Service Bulletin

Bulletin No. 2006-13
OEM No. 2006-09

Official Recall Notification Federal Boat Safety Act Commander 3000 Remote Control

Situation

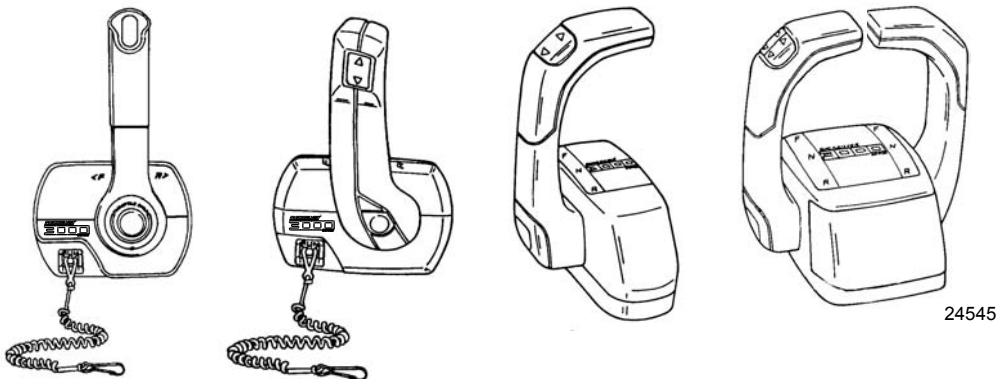
Commander 3000 remote controls built between June 1, 1994 and September 1, 1995 could fail; resulting in the inability to reduce throttle, and shift the engine out of gear. This failure is caused by an improperly hardened gear in the control mechanism. The Gen I Commander 3000 Remote Control is No Longer Available (NLA). This Service Bulletin reflects the use of the Gen II Remote Control as a replacement part, along with the Gen II Throttle and Shift Cables.

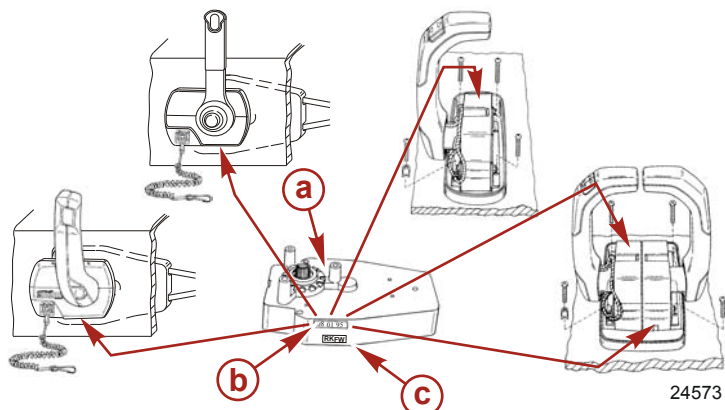
2. **Determine if you have a Commander 3000 control that is included in this recall.** View the decals on the control, if visually accessible, in the location shown below. Use a flashlight and mirror to help read the decals.

IMPORTANT: You are affected by this recall, and the control mechanism must be replaced, if it was built between June 1, 1994 and September 1, 1995 and does not have a "RKFV" decal on it.

a - Control Mechanism
b - Build Date Decal

c - RKFV Decal

NOTE: The date may appear on the control in different forms: 08/01/95 (month/day/year) August 1, 1995. The month may also be written out in alpha characters as in the following: Aug/1/95 or 1/Aug/95. Decals may be placed in other locations.
